SITE INSTRUCTION

SI A13

PROJECT : Forestside
PROJECT # : 1331.15
DATE : Dec. 3, 2021

Title: Revisions to plans as itemized.

1:100 A402

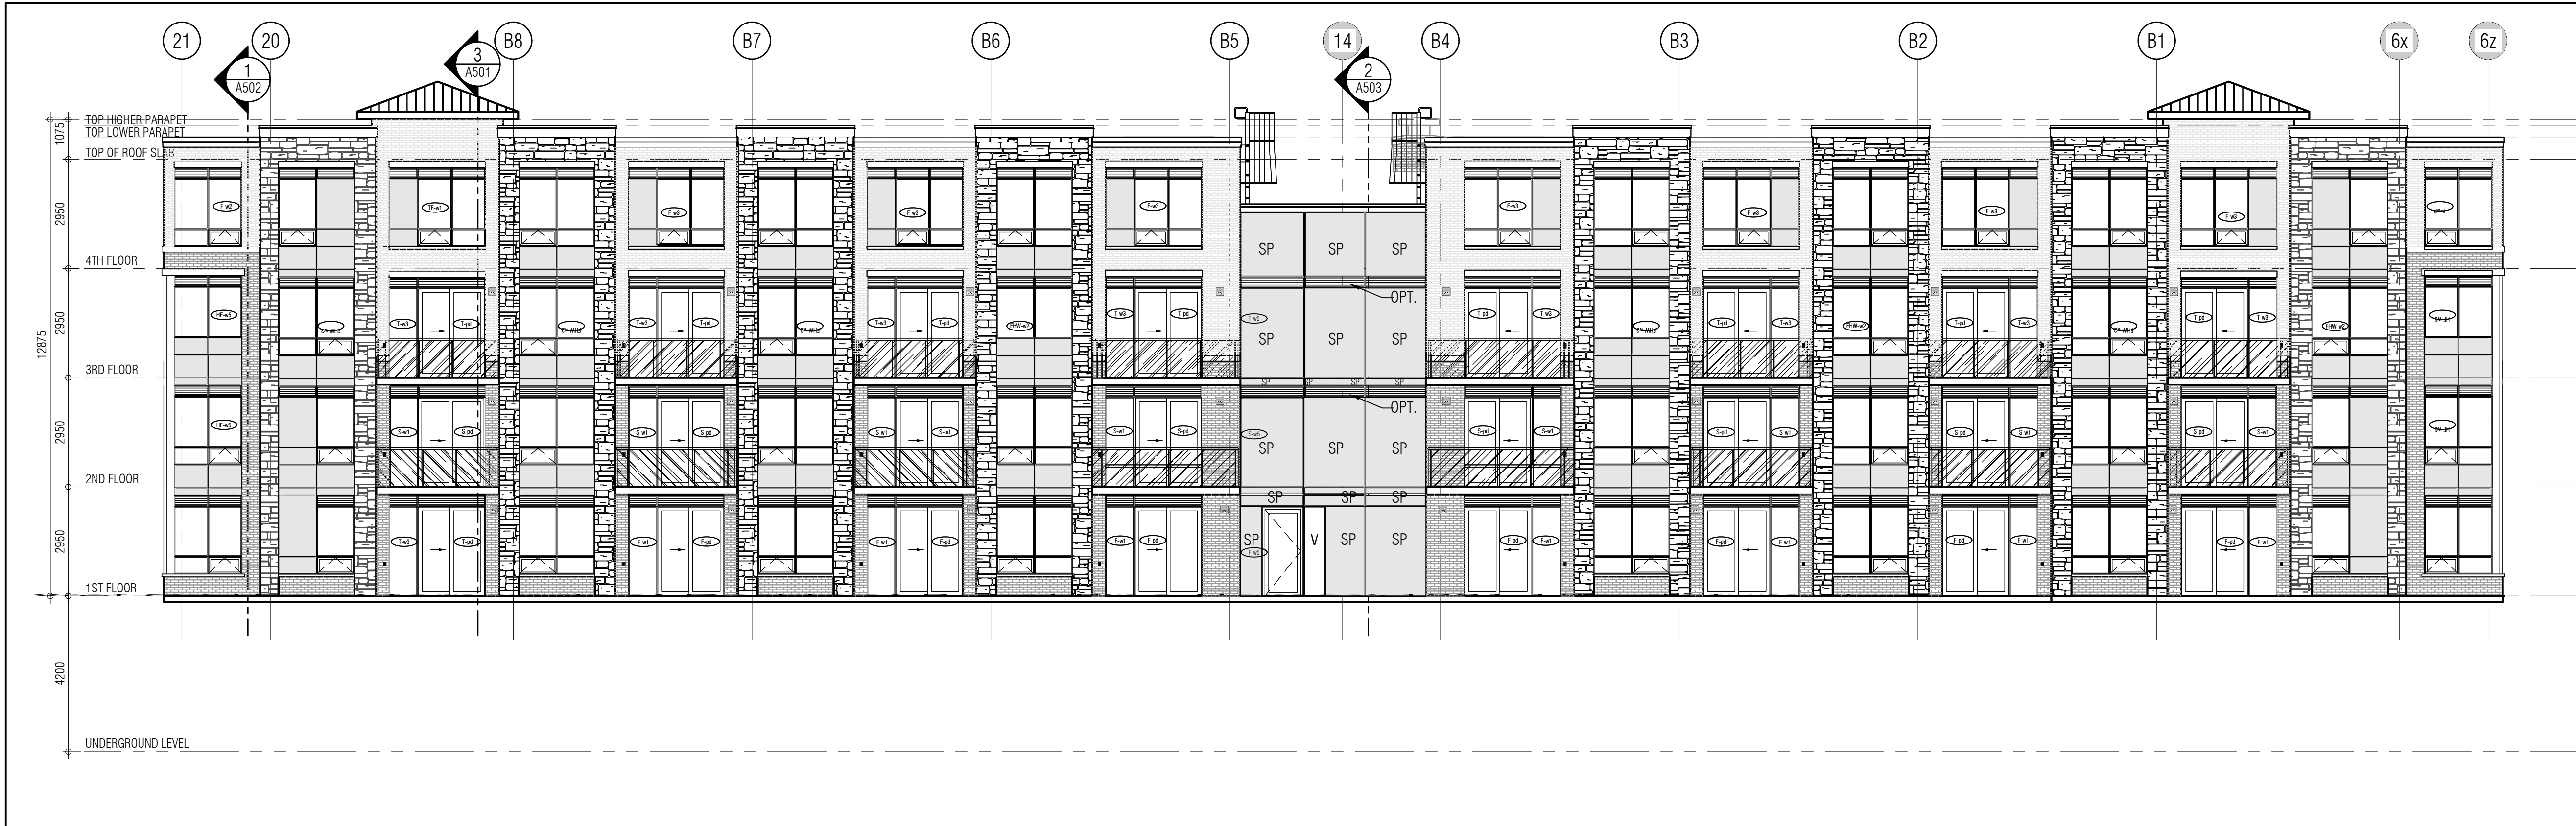
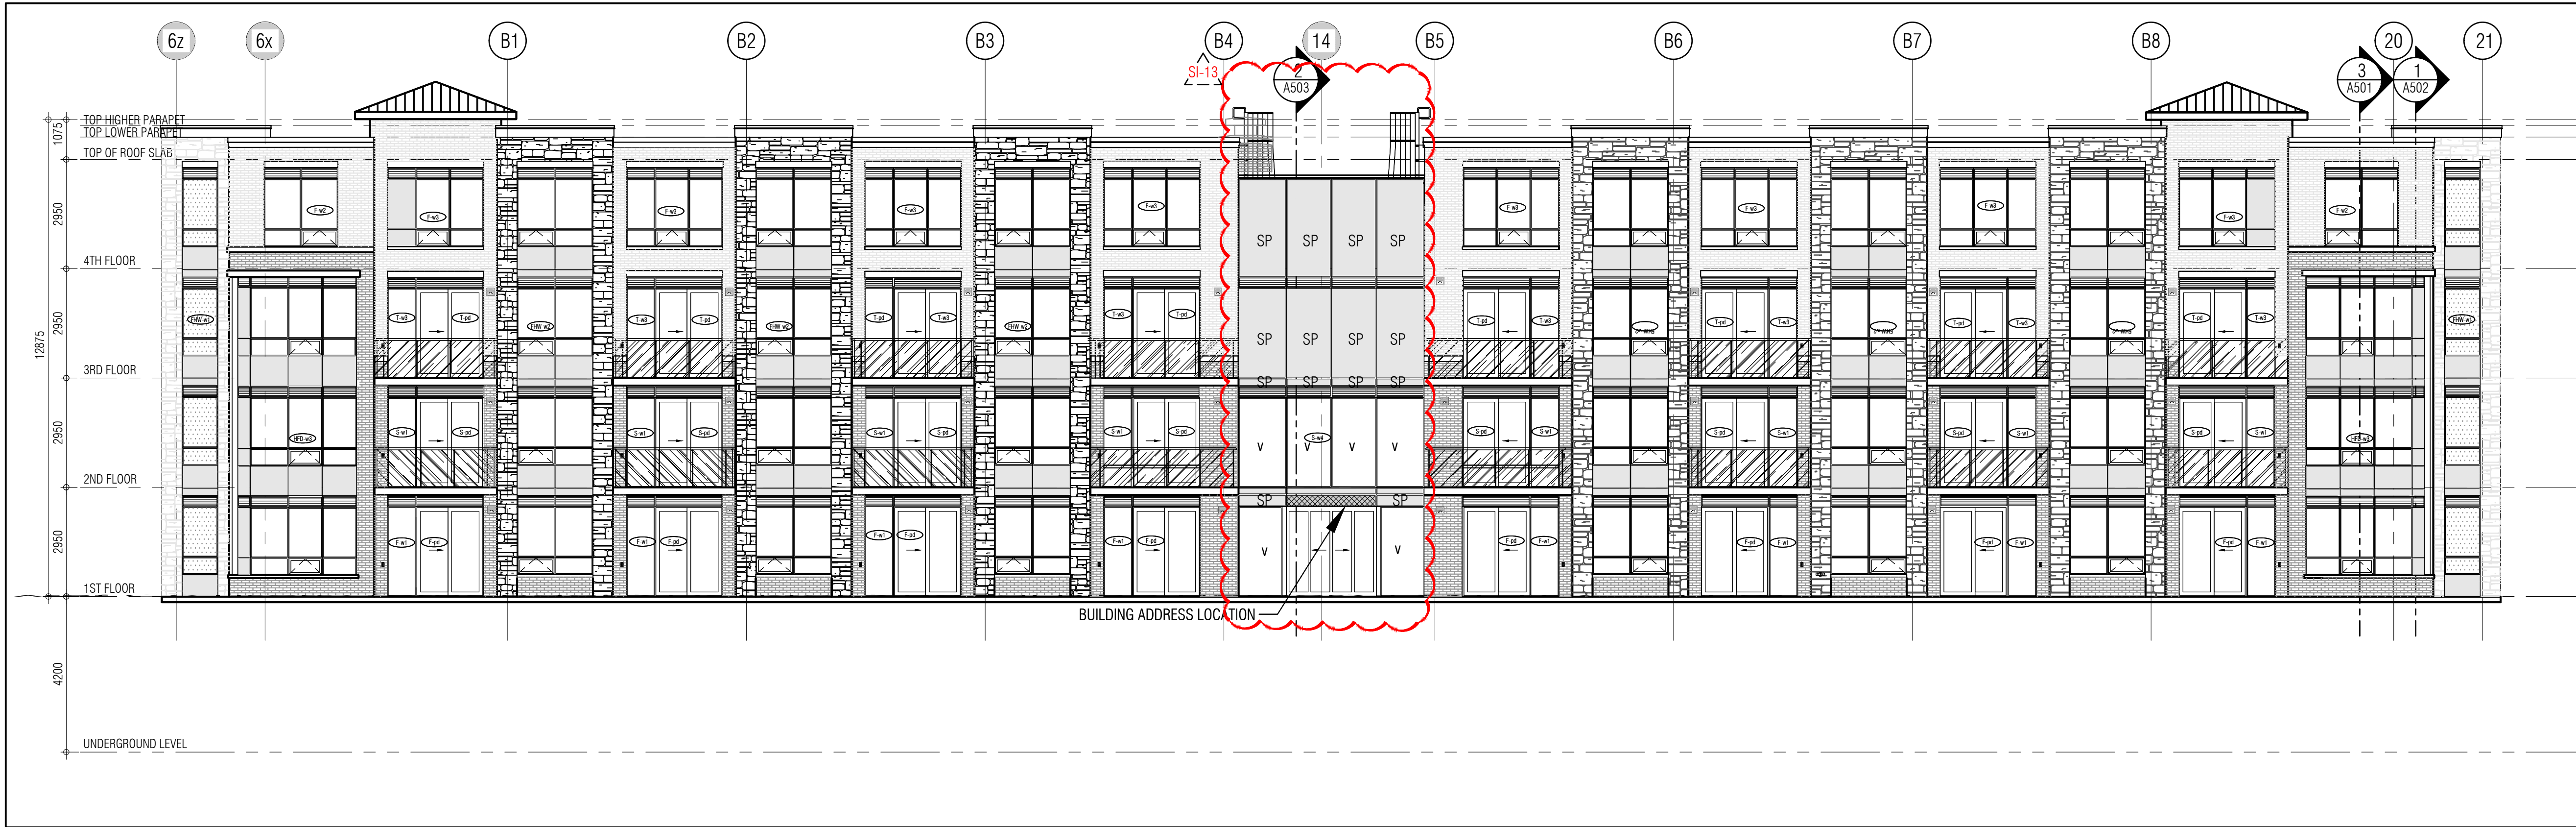
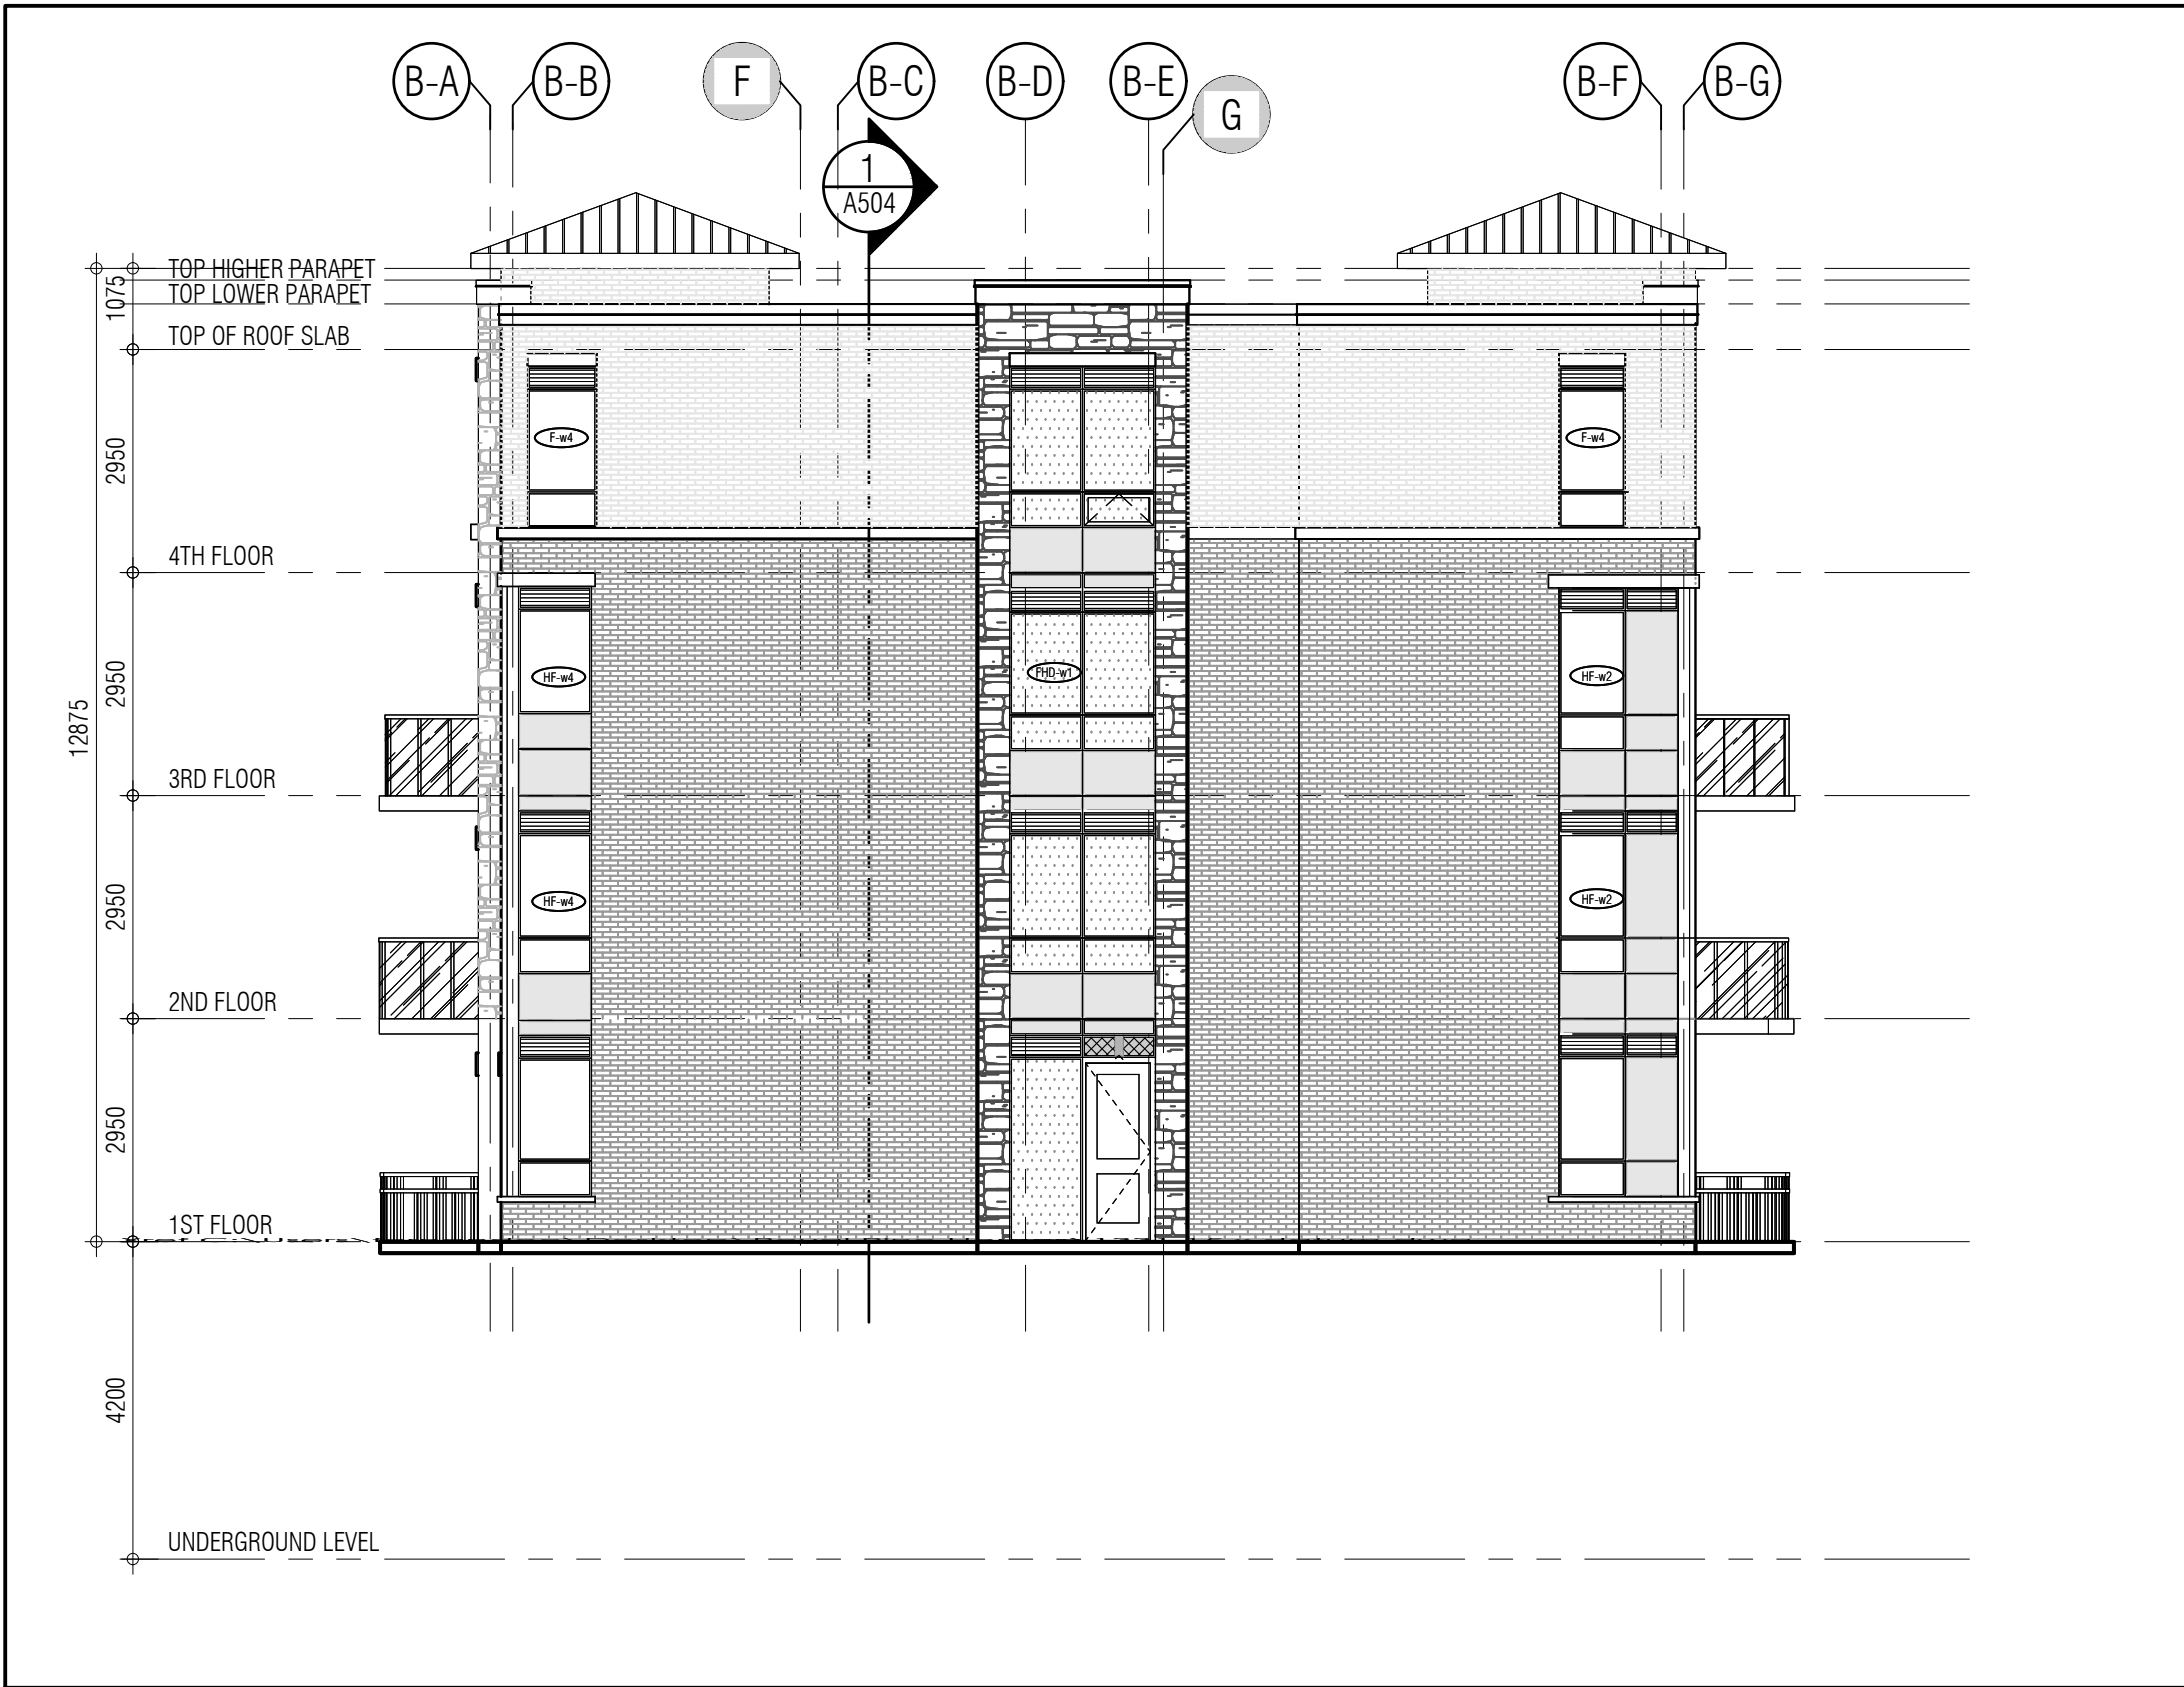
Reference:		Changes:
CS304a1, a2 CS304b1, b2 CS304c1, c2 CS304d1, d2	4th Floor Slab Edge	Revise spot elevation of higher roof parapet at front lobby wall.
A401, A401a1 A402, A402b2 A403, A403c1 A404, A404d1	Elevation Building A Elevation Building B Elevation Building C Elevation Building D	Revise height of window wall, louvre location heights to match front lobby wall parapet height.
A503	Sections	Revise dimensions, window wall, and louver location heights of front lobby wall parapet match window shop drawings.
A900	Window Schedule	Revise dimensions, window wall, and louver location heights of front lobby wall parapet match window shop drawings.

Reason: Revisions to plans of parapet heights and as per window shop drawing coordination at front lobby wall.
